Omaha Public Power District

Fort Calhoun Station (FCS), Unit 1
Renewed Facility Operating License No. DPR-40
NRC Docket No. 50-285

Subject: License Amendment Request (LAR) 16-01; Revised Commitment to Modify FCS Plant Systems as Part of the Implementation of NFPA 805

Enclosure, License Amendment Request (LAR) 16-01; Revised Commitment to Modify FCS Plant Systems as Part of the Implementation of NFPA 805

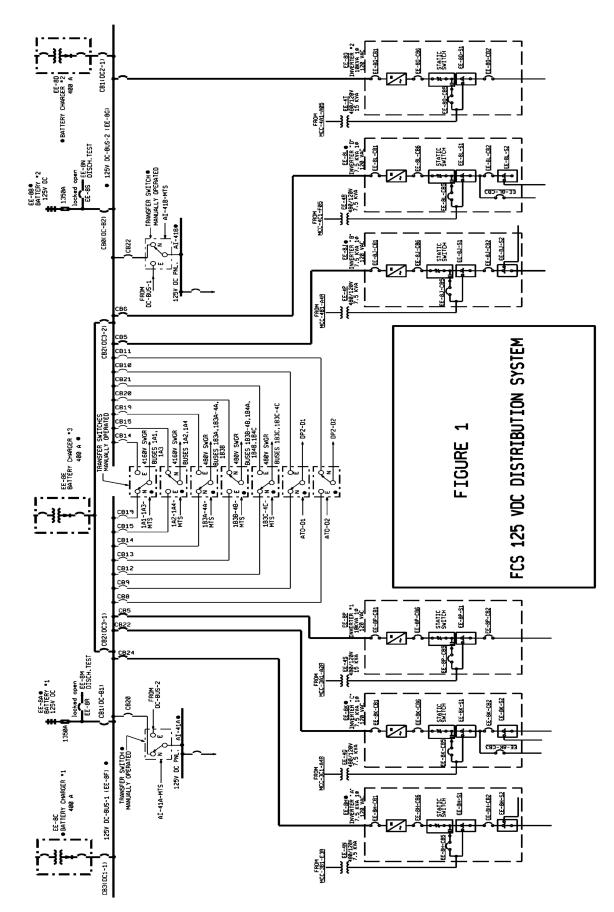
The FCS 125 VDC distribution system consists of two separate trains each of which has its own DC distribution bus, a battery which is connected directly to the bus and a battery charger powered from the associated 480 VAC train, also connected to the bus. The battery charger carries the DC load during normal plant operation while the battery is maintained in a standby condition ready to supply the bus in the event of a loss of battery charger operation or to supplement the battery charger during DC load transients. The system also includes a third battery charger that can be used to supply either DC bus from either train of 480 VAC power. The third charger is not normally in operation but can be manually placed in service during maintenance of train dependent chargers or in the event of charger failure.

Refer to Figure 1 for additional information regarding the DC system arrangement.

Each battery is connected to its associated DC distribution panel via a non-automatic circuit breaker (i.e. a manually operated switch) located at the DC distribution panel which is mounted in the associated train-dependent switchgear room.

Each DC bus normally provides power to three instrument inverters, two safety related and one non-safety related. Instrument inverters provide 120 VAC power to instrument buses for plant instrumentation and protective circuit components, including degraded-voltage relays. The instrument buses all have backup power capability from bypass transformers powered by the 480 VAC system. Each bypass transformer is placed in service by the operation of an automatic static switch in the event of associated inverter failure or loss of DC power to the inverter.

The DC buses also supply numerous other loads including control power for 480 and 4160 VAC circuit breakers, control room DC distribution panels and diesel generator starting and field flash circuits. Power to these loads is routed through manually-operated transfer switches that permit power to be supplied from either DC train. The transfer switches and the procedural direction for their use were both part of the original plant design. The transfer switches for control room DC distribution panels are located in the control room while other transfer switches are located near the associated loads. Power to DC controlled valves is provided from the main control room DC distribution panels, designated as Al-41A and Al-41B, associated with DC-Bus-1 and DC-Bus-2, respectively.
